Scope of the revision

29th Floor - M-529 SD R2: Bubbled Areas

30th Floor - M-530 SD R2: Scope and Quantities

31st Floor - M-531 SD R2: Scope and Quantities

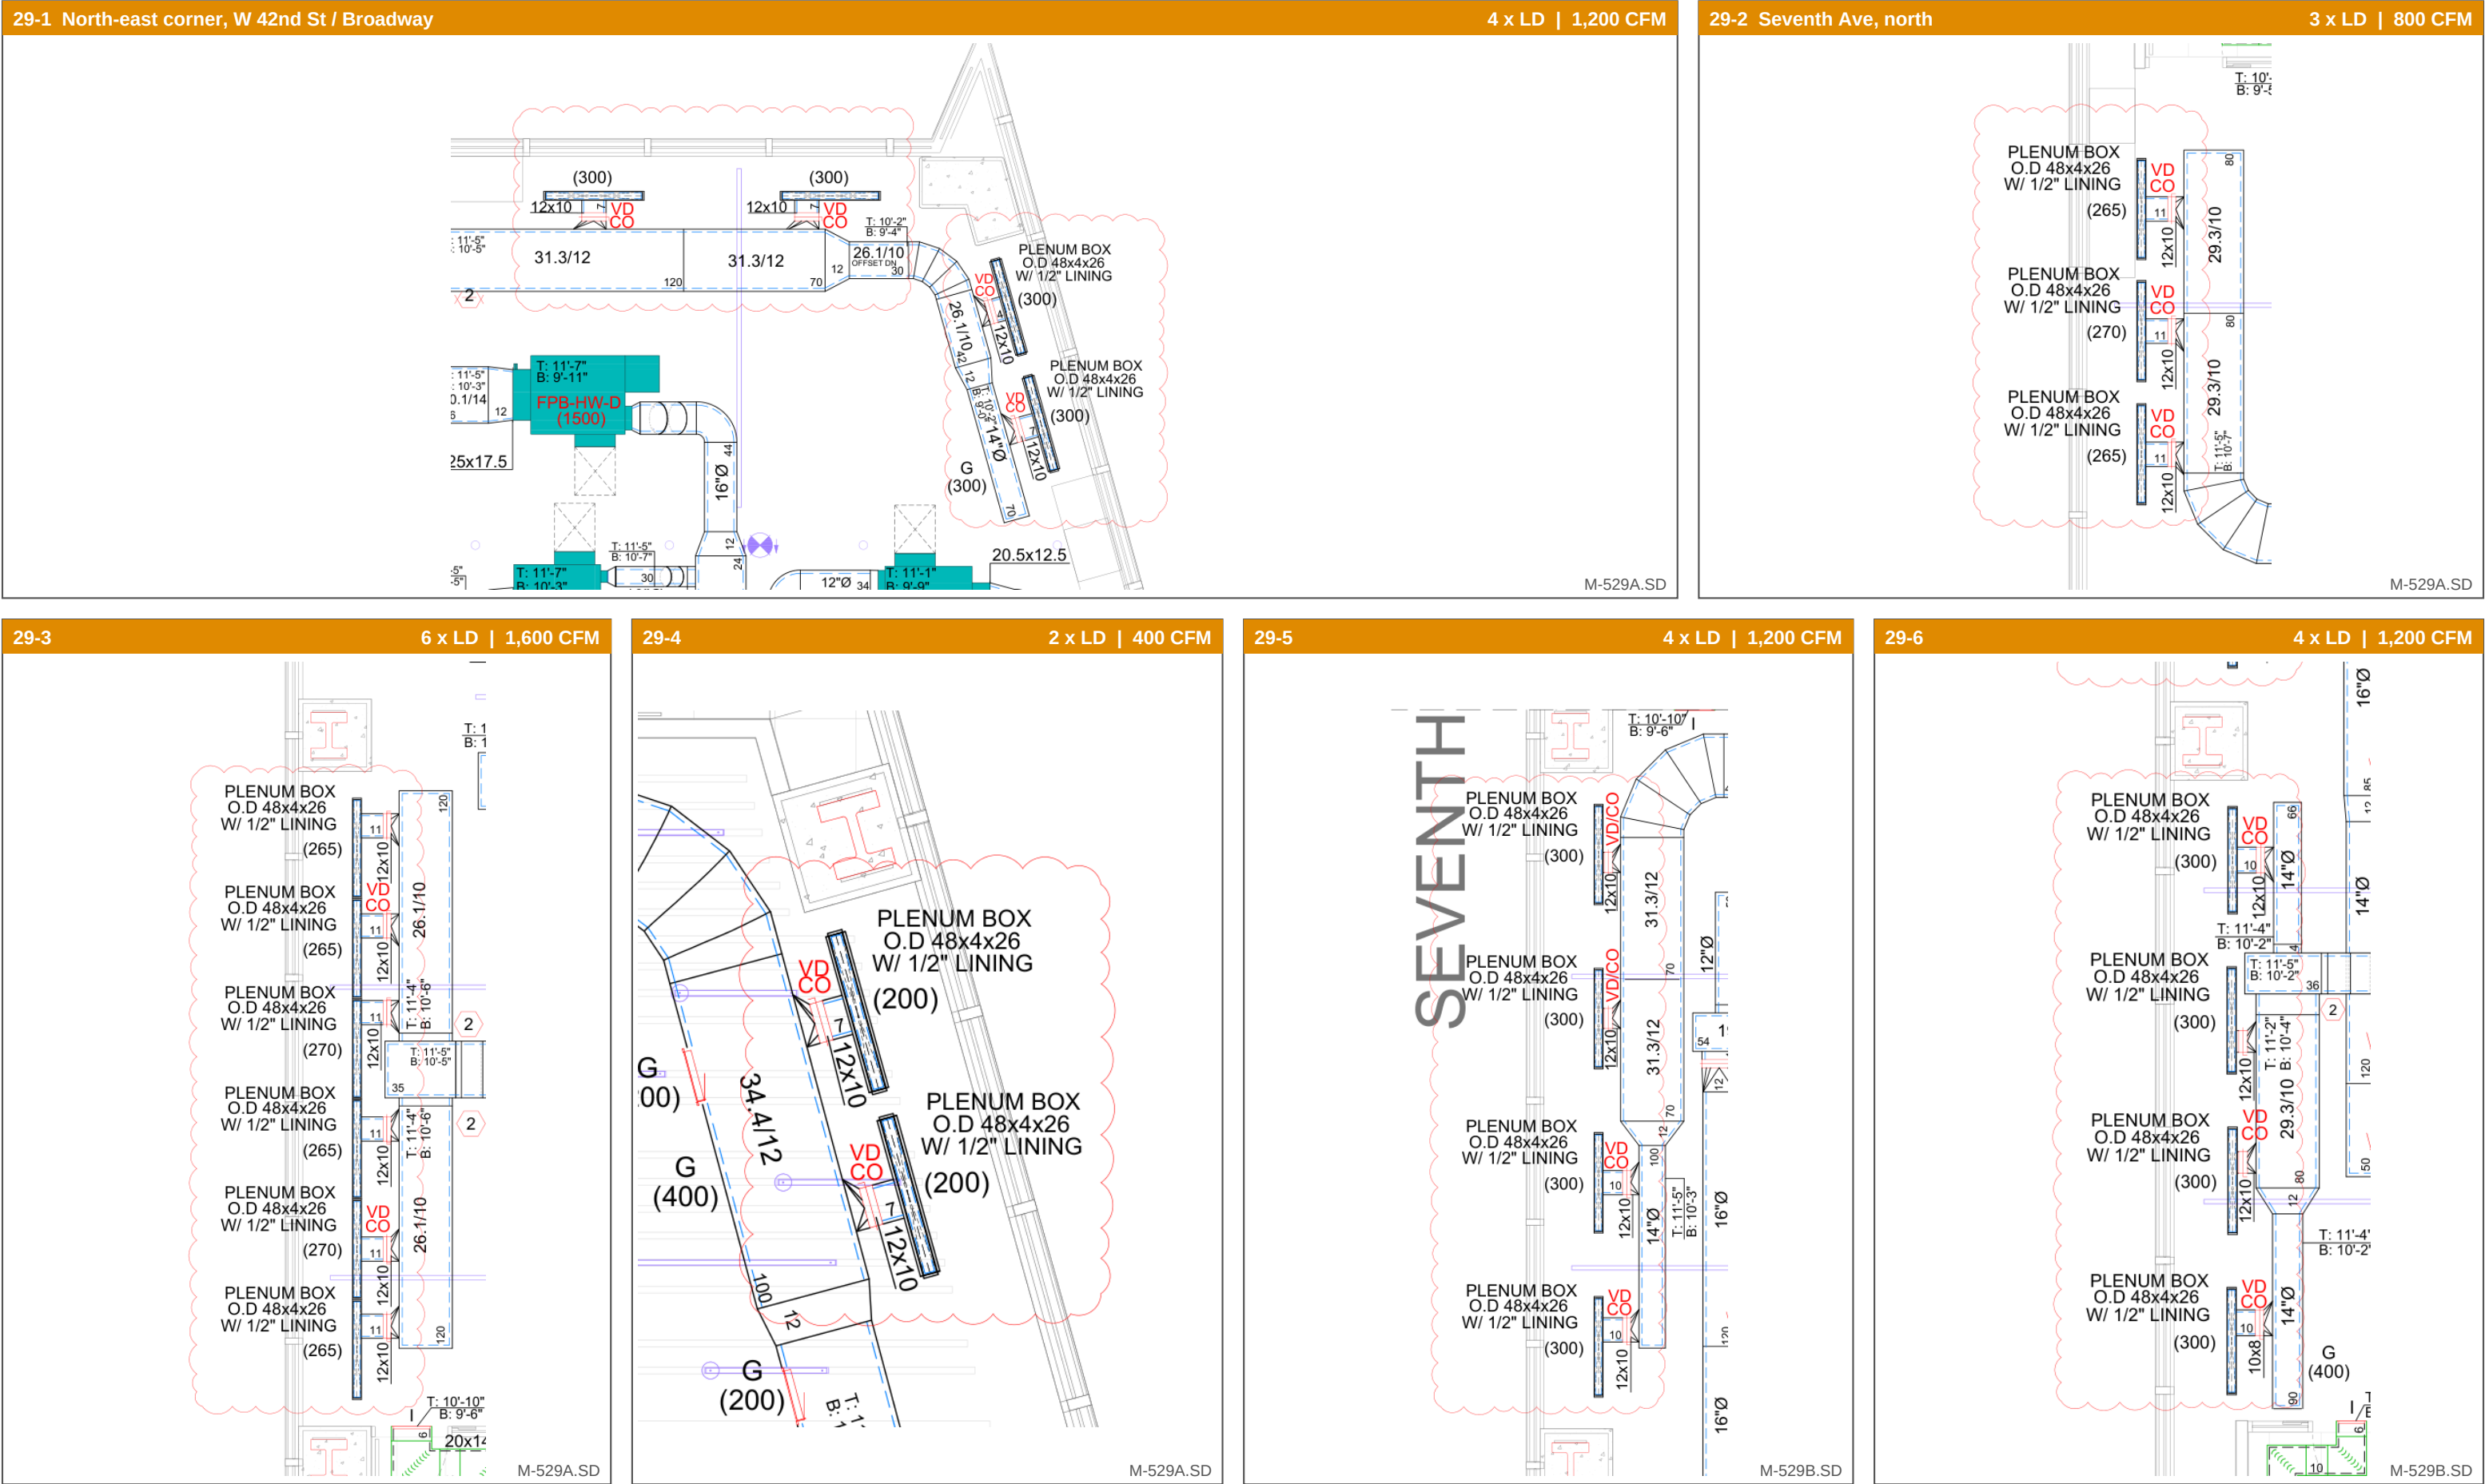
23 perimeter linear diffusers in plenum boxes O.D. 48x4x26 w/ 1/2" lining, 6,400 CFM | quantities on next page

29th Floor - M-529 SD R2: Scope and Quantities

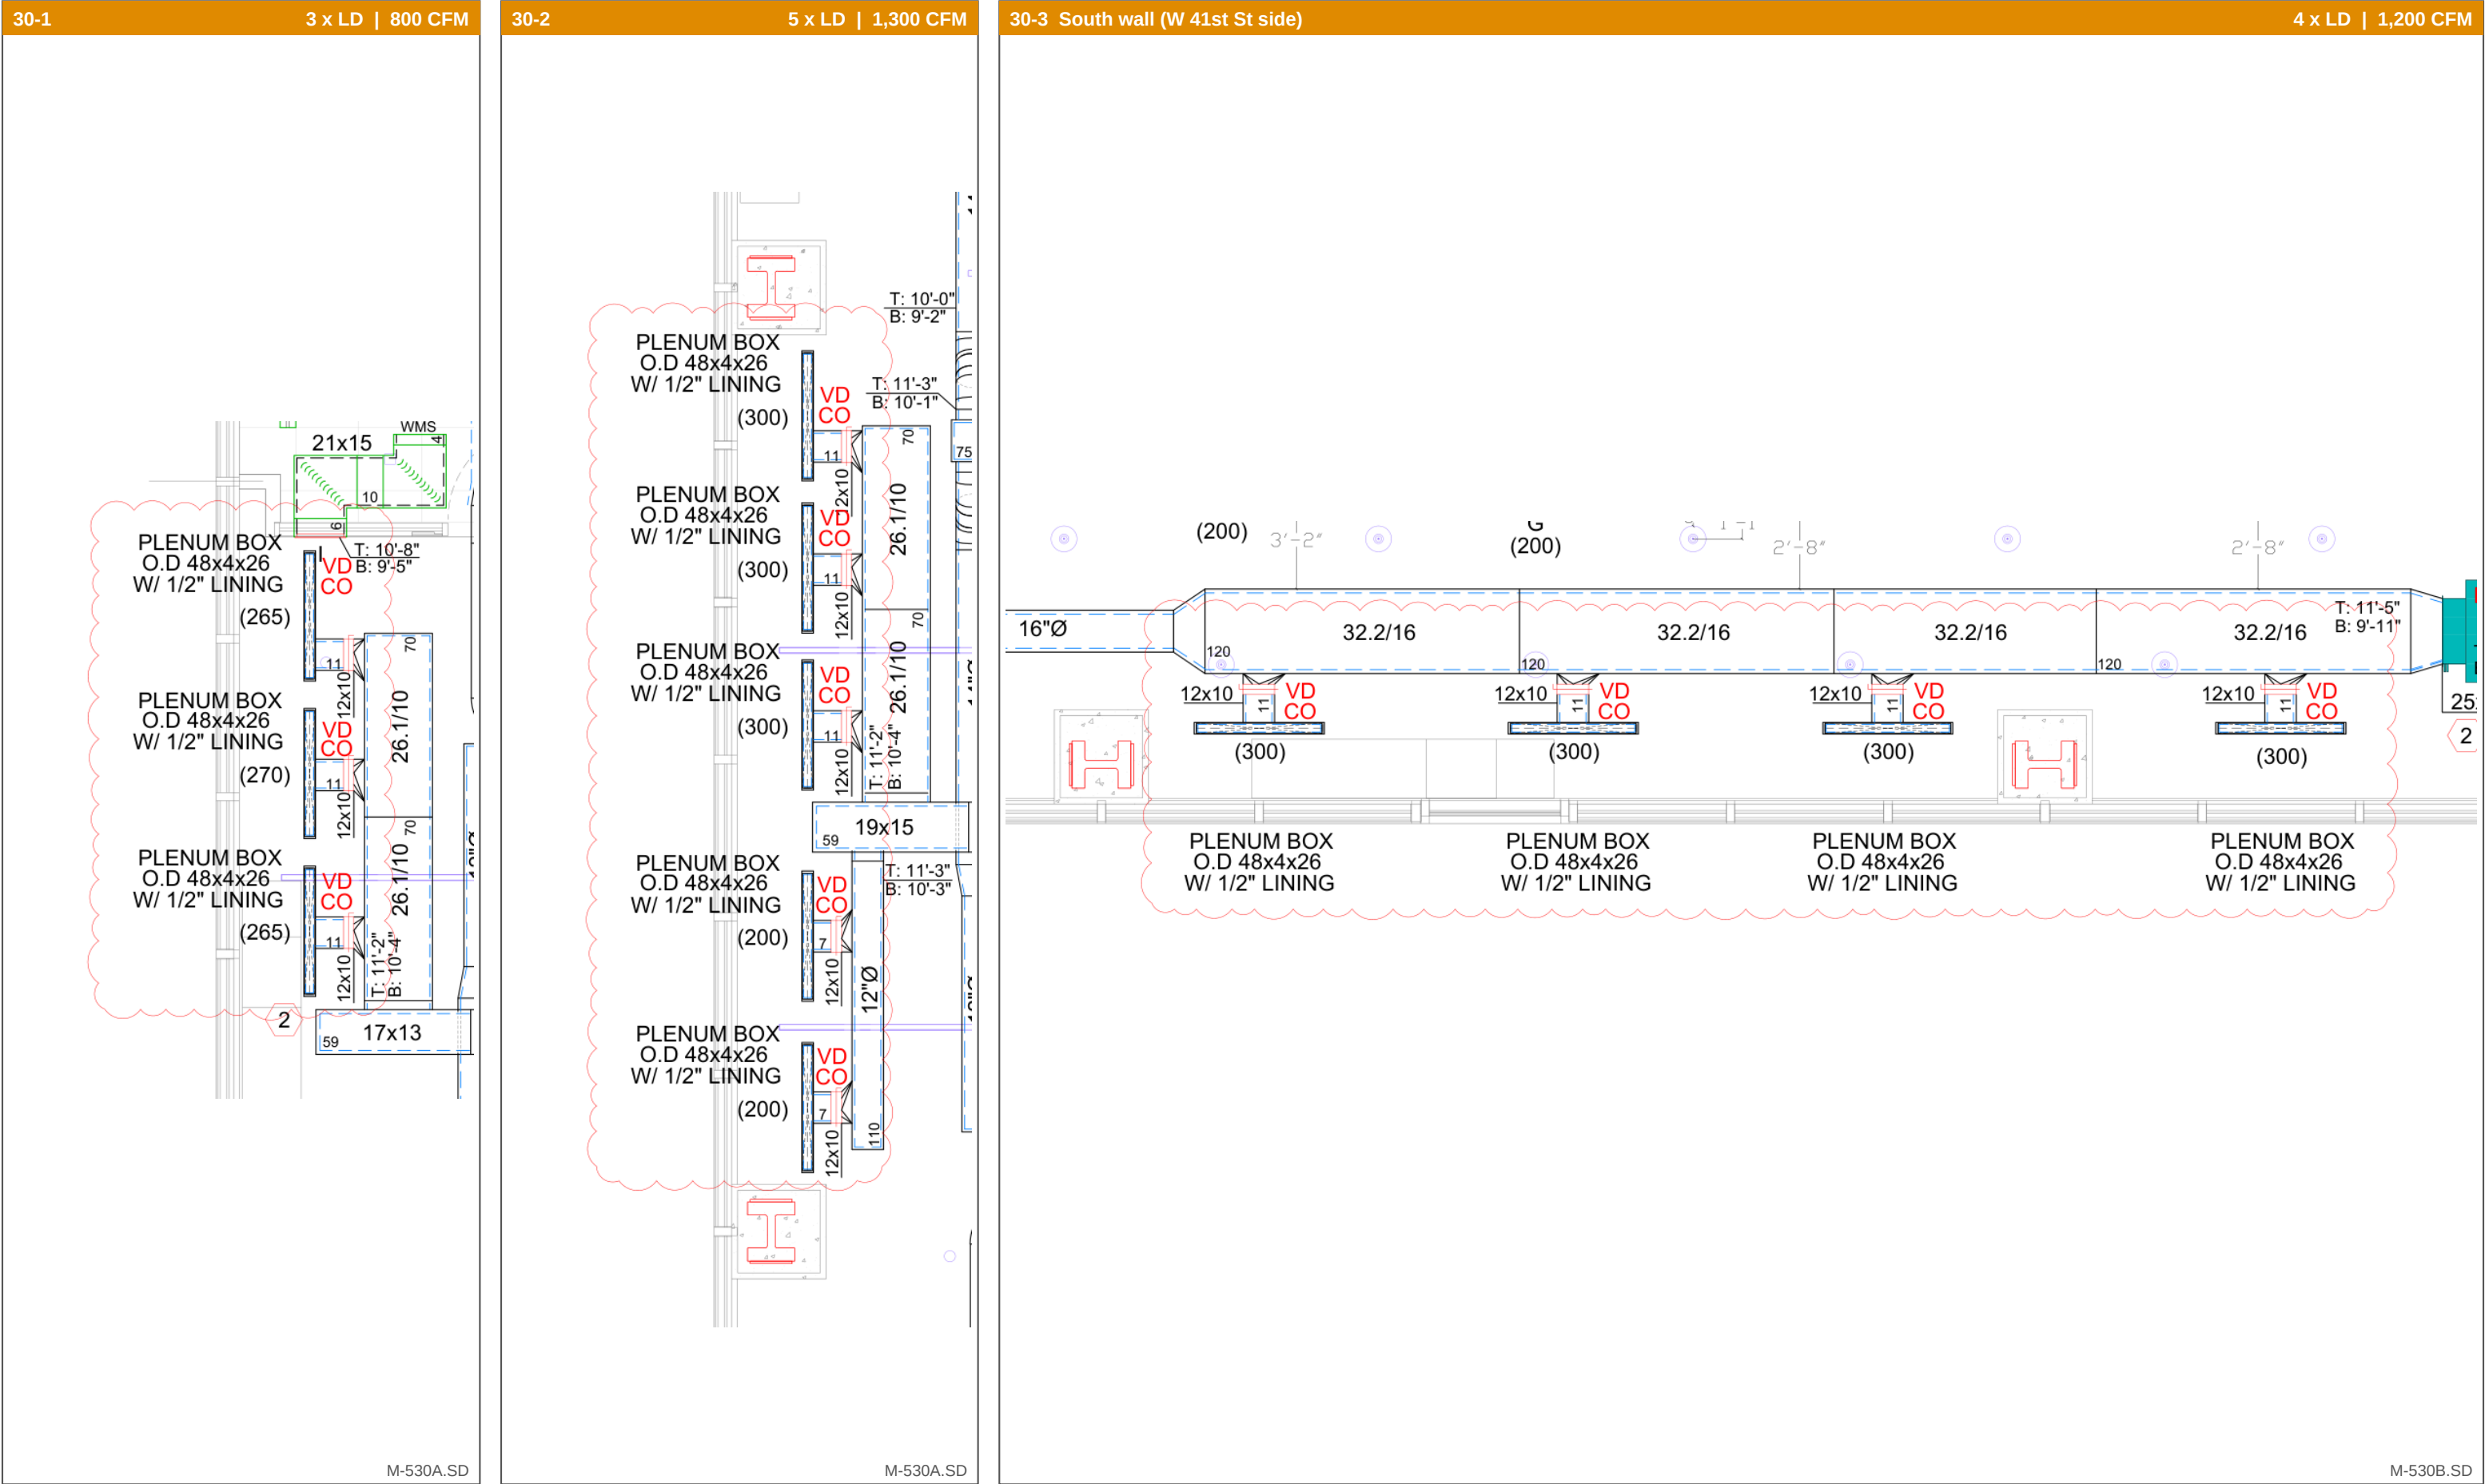
Area	Location / scope	LD qty	CFM each (total)	Branches	VD/CO tagged	Perimeter main in bubbled area (existing to remain, not priced)
29-1	North-east corner, W 42nd St / Broadway F&I 4 perimeter linear diffusers with plenum boxes; 4 branch taps off main with VD/CO, insulation, soffit coordination. 2 diffusers along 42nd St off the 31.3/12 main, 2 along Broadway off the 26.1/10 / 14"Ø run.	4	300 / 300 / 300 / 300 (1,200)	4 x 12x10, 25 in total	4	31.3/12 approx. 16 LF; 26.1/10 with offset down approx. 6 LF; 14"Ø approx. 6 LF
29-2	Seventh Ave, north F&I 3 perimeter linear diffusers with plenum boxes; 3 branch taps off main with VD/CO, insulation, soffit coordination.	3	265 / 270 / 265 (800)	3 x 12x10, 33 in total	3	29.3/10 approx. 13 LF
29-3	Seventh Ave, Open Office 29.42 F&I 6 perimeter linear diffusers with plenum boxes; 6 branch taps off main with VD/CO, insulation, soffit coordination. VD/CO tagged on 2 of 6 connections.	6	265 / 265 / 270 / 265 / 270 / 265 (1,600)	6 x 12x10, 66 in total	2	26.1/10 approx. 20 LF (with tee)

29-4	Broadway, north F&I 2 perimeter linear diffusers with plenum boxes; 2 branch taps off main with VD/CO, insulation, soffit coordination.	2	200 / 200 (400)	2 x 12x10, 14 in total	2	34.4/12 approx. 8 LF
29-5	Seventh Ave, south (north end of sheet B) F&I 4 perimeter linear diffusers with plenum boxes; 4 branch taps off main with VD/CO, insulation, soffit coordination.	4	300 / 300 / 300 / 300 (1,200)	4 x 12x10, 40 in total	4	31.3/12 approx. 12 LF; 14"Ø approx. 8 LF
29-6	Seventh Ave, south F&I 4 perimeter linear diffusers with plenum boxes; 4 branch taps off main with VD/CO, insulation, soffit coordination. Last connection 10x8. VD/CO tagged on 3 of 4.	4	300 / 300 / 300 / 300 (1,200)	3 x 12x10, 30 in total 1 x 10x8, 10 in total	3	14"Ø approx. 13 LF; 29.3/10 approx. 7 LF
	29th floor total	23	6,400	22 x 12x10 1 x 10x8	18

31-1 Seventh Ave, north (Focus Rm 31.65 / Corridor 31.51)

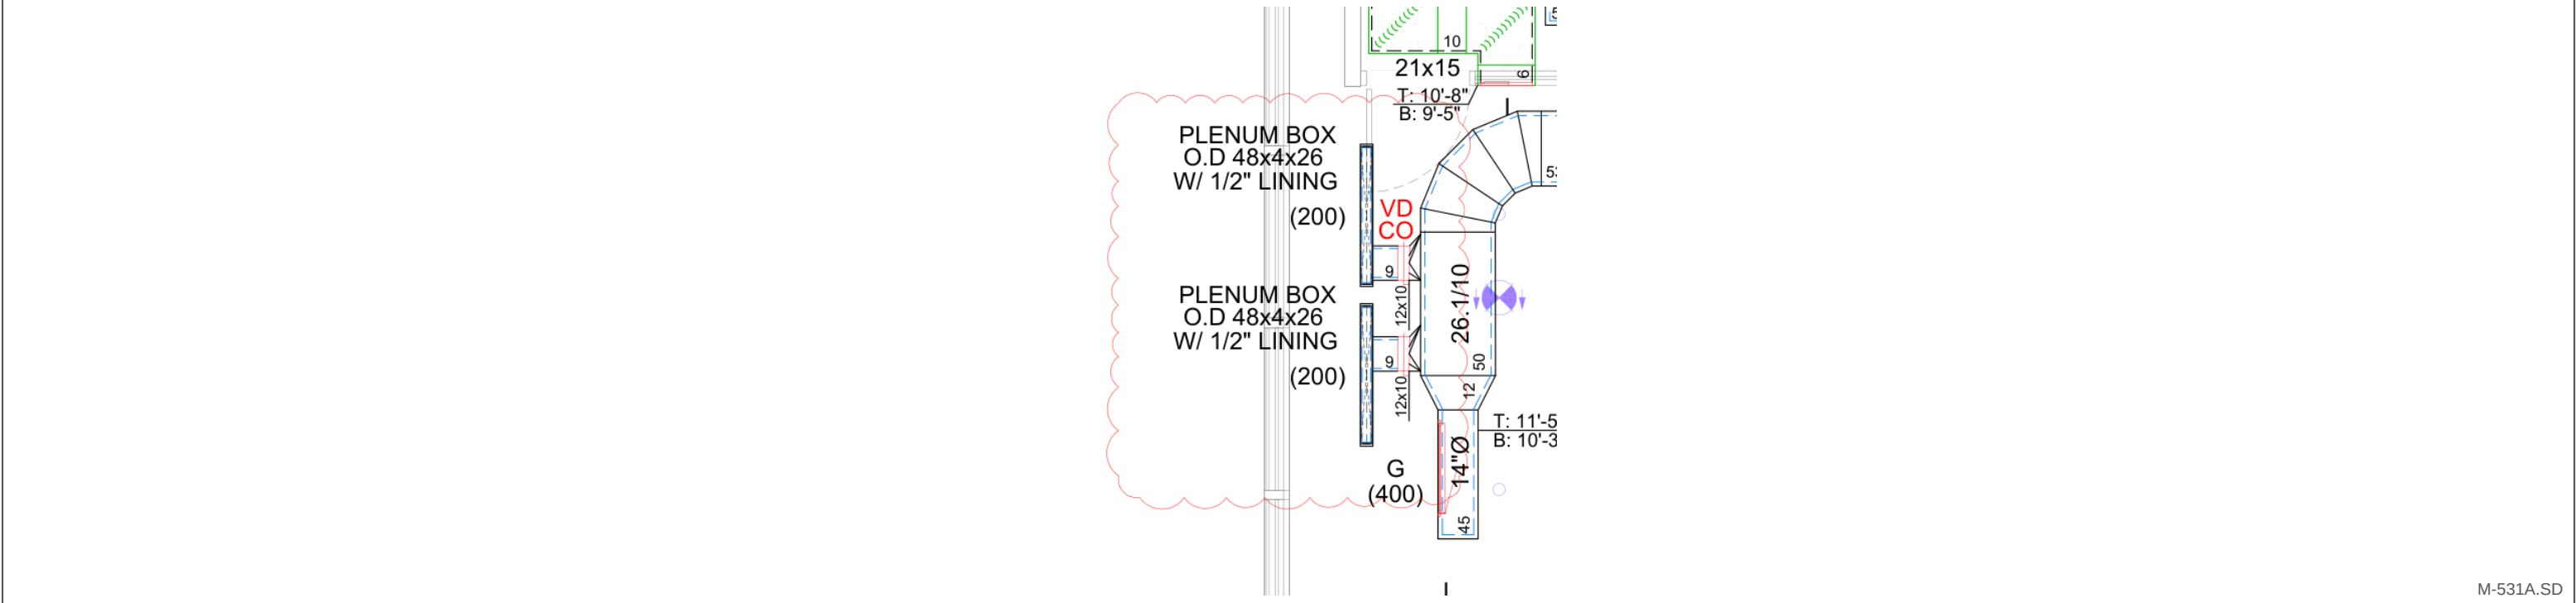
2 x LD | 400 CFM

31-2

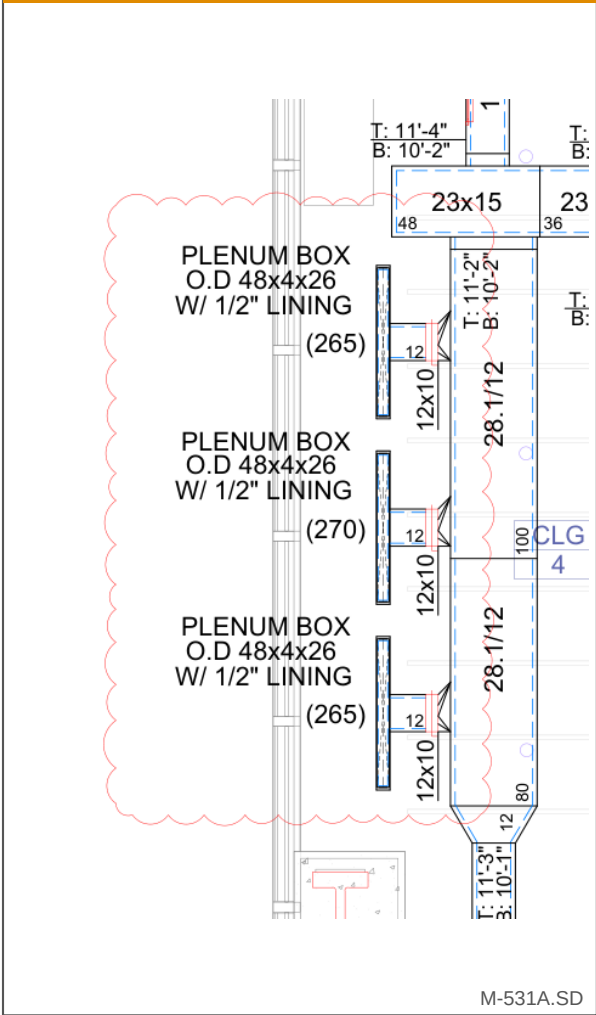
3 x LD | 800 CFM

31-3

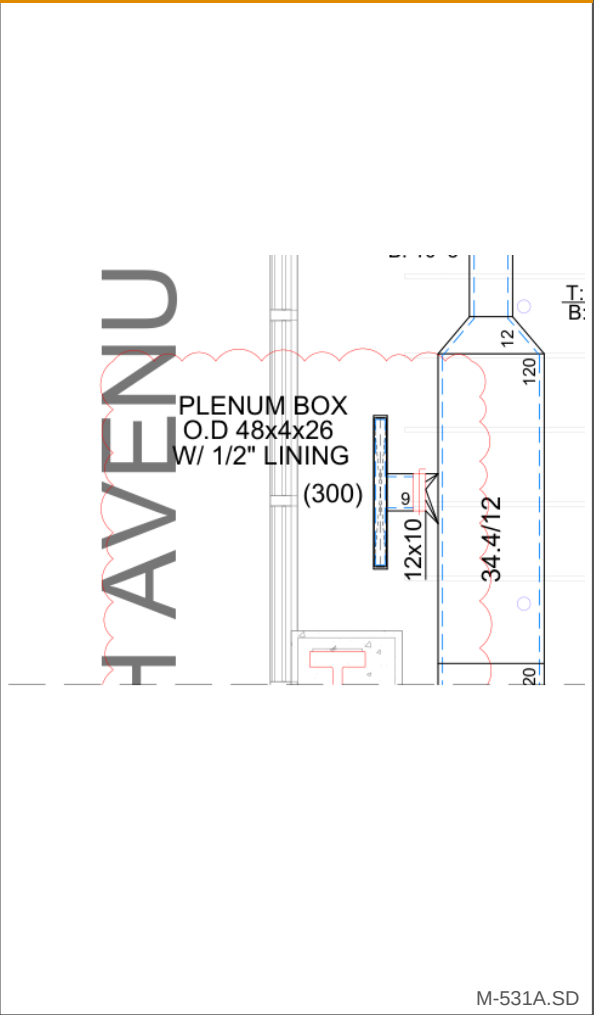
1 x LD | 300 CFM

31-4

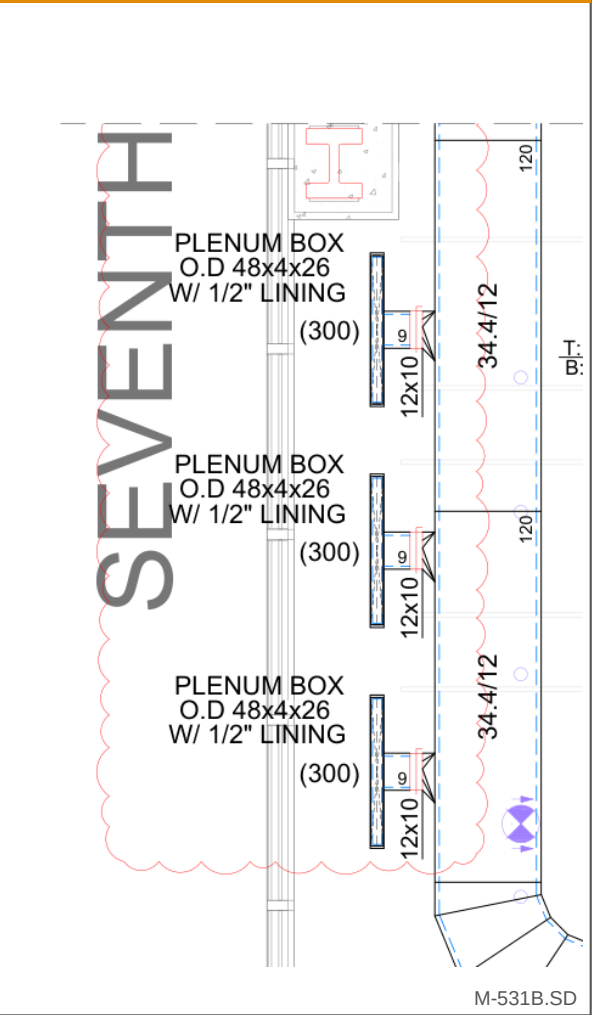
3 x LD | 900 CFM
